CITY OF PORTLAND, MAINE

Maple St., Peaks Island-I
(Assessor's Lot No. 85-J-30)

Subject: Alterations to former bakery to provide
living quarters therein at Maple Street, Peaks
Island, Assessor's Lot No. 85-J-30

WILLIAM COTTON
MAPLE ST. - PEAKS ISLAND

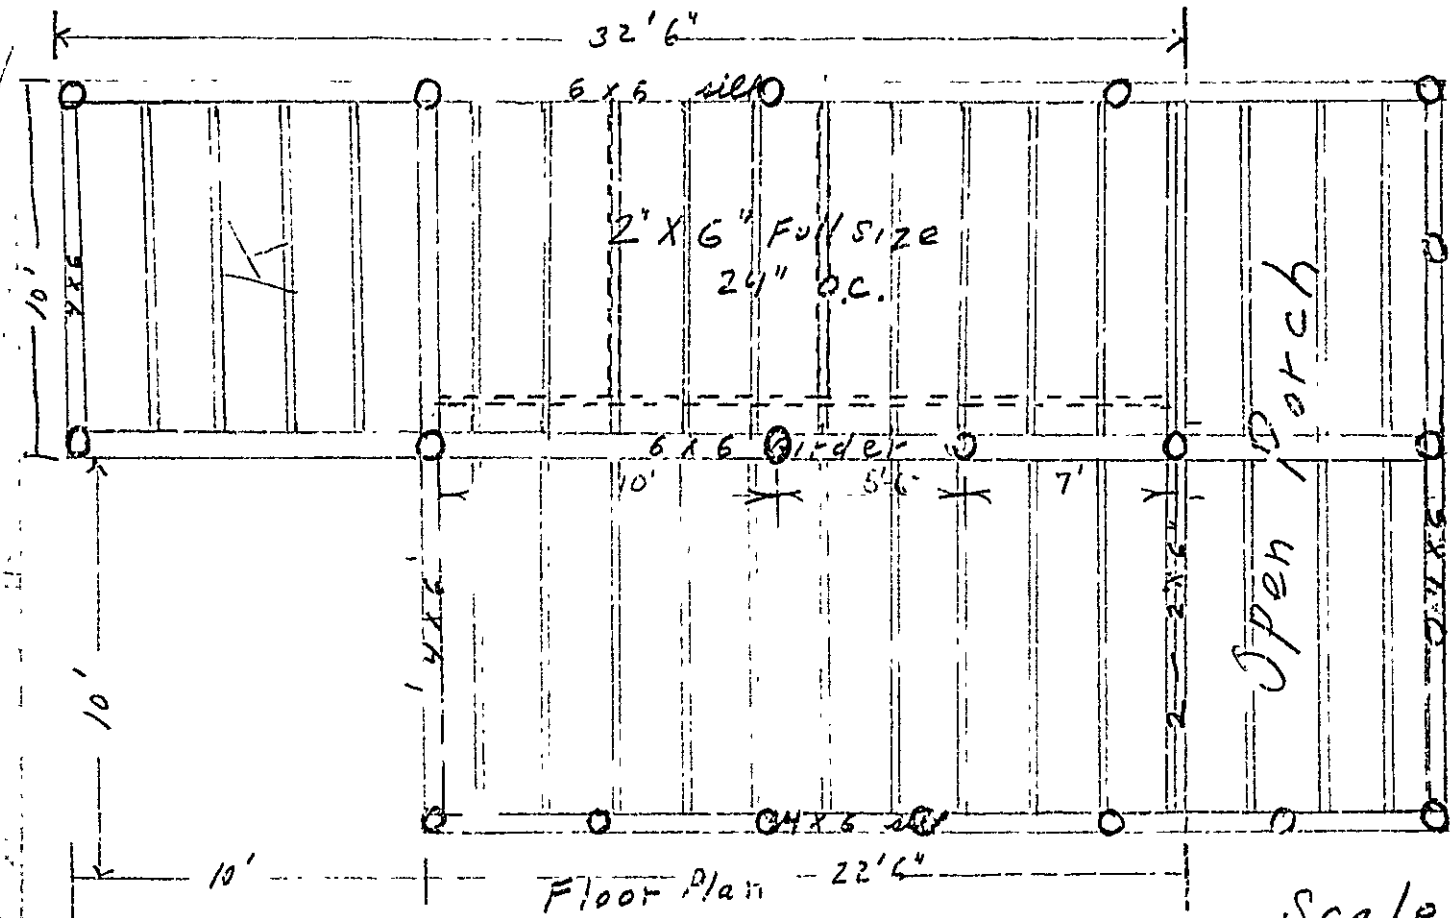
$$\begin{aligned}
 BJ + EG &= 7\frac{1}{2} \times 500 = 3610^{\#} \\
 CI + DH &= 4\frac{1}{2} \times 500 = 2438^{\#} \\
 JI + GH &= 2\frac{1}{2} \times 500 = 1156^{\#} \\
 JK + GK &= 7\frac{1}{2} \times 500 = 3531^{\#} \\
 IH &= 1 \times 500 = 500^{\#}
 \end{aligned}$$

$$BJ + EG - f = 700 \left(1 - \frac{60}{20 \times 2}\right) = 438^{\#}$$

$$438 \times (2 \times 4) = 3504^{\#} \text{ SAFE LOAD (ACTUAL } - 3610^{\#}) \text{ O.K.}$$

$$JI + GH - f = 700 \left(1 - \frac{60}{20 \times 2}\right) = 175^{\#}$$

$$175 \times (1 \times 6) = 1050^{\#} \text{ SAFE LOAD (ACTUAL } - 1156^{\#}) \text{ O.K.}$$

$$\frac{5 \times 12}{1} = 60 (?) \quad \frac{3}{2} = 50 \text{ MAX. ALLOWABLE ?}$$

$$JK + GK = \frac{3531}{1100} = 3.21 \text{ sq in area } \times \frac{5}{8} = 5.22 \text{ sq in req}$$

$$2 \times 4 = 8 \text{ sq in actual - O.K.}$$

$$IH = \frac{500}{1100} = 4.54 \text{ sq in } \times \frac{5}{8} = 7.76 \text{ sq in req}$$

$$1.75 \times 5.75 = 10 \text{ sq in actual O.K.}$$

Roof Truss
24" o.c.

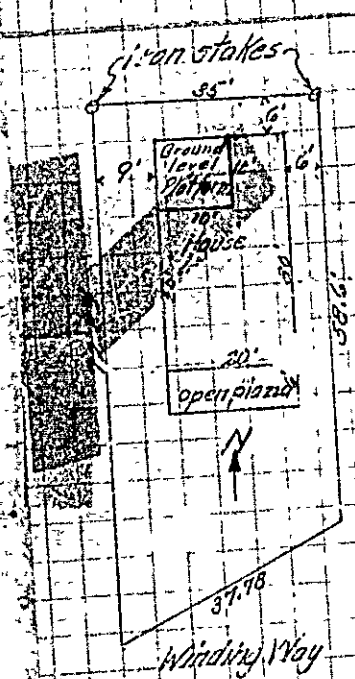
Think we will
have to park ^{over} the con-
struction of this bldg.
as regards requirements
for dwelling house, etc.
if you can find out
if all year round
dwelling is planned
or only summer cot-
tage. Also check on
distance to lot lines
suppose side yard
distances of 10' and
rear yard distance
of 20' or 25' or the
depth of the lot will
apply. A.C.

Mrs. Cotton said the two iron stakes shown were near and side line stakes. There are no front stakes, nor defined street line. On location the bldg. seems closer to street than it runs out, but this is a rough traveled road and could be several feet off. This sketch checks fairly good with insurance data.

Structural - Sills are 4x6 on edge, center girders 6x6. Straps of material between girders 1st floor prevented getting post spacing. Mr. Hoar agreed as a as creature permits to provide necessary post and required spacing.

First floor is 2x6 or 24" center 10' spans 9' rd for 638-32 # # he prefers to put in additional girders with 20' spacing to put in extra 2x6's

4. We understand that the roof of the building is to be reinforced by adding additional members to tie the rafters and ceiling timbers together so that they will act as individual trusses. The arrangement shown on plan submitted should work out all right if the new diagonal members are fastened to the rafters at the center of the span and are made 2" x 4" instead of 1" x 6" as indicated. The vertical member from center of ceiling timber to ridge, however, is all right as a 1" x 6" as shown. Since the joints are one of the most important details of a truss, care must be used to fasten the different members securely together, including the joint where rafters and ceiling timbers meet over the plate, and to avoid any splitting of timbers when fastening is made.
